Code Administrator Consultation

CMP470: Introducing an Oversubscribed Technologies Commitment Fee

Overview: This modification seeks to introduce a floor on securities through an Oversubscribed Technologies Commitment Fee for all technologies which are oversubscribed relative to Clean Power 2030 capacity targets.

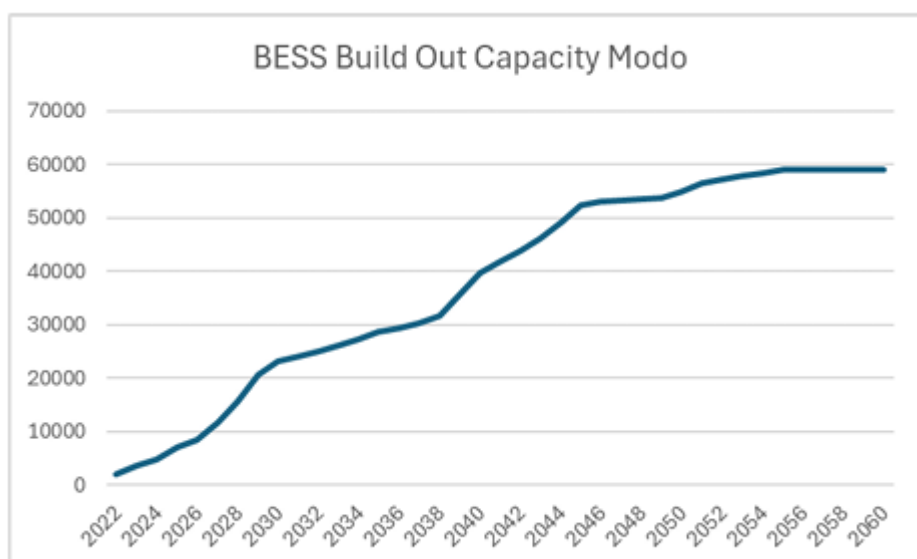
Another respondent provided BESS build-out forecast data from Modo Energy (**Annex 07**) and a graph (Gate 2 pipeline snapshot) to detail how projected BESS deployment requirements for 2035 and 2050, allowing for comparison with existing Clean Power 2030 targets. While Clean Power 2030 sets an ambition of 23–27 GW of BESS by 2030, projections for 2050 indicate the need for significantly greater capacity to support a decarbonised power system and increased renewable penetration. Long-term projections indicate that BESS capacity could need to reach 60–80 GW or more by 2050 to support full decarbonisation, system balancing, and security of supply.
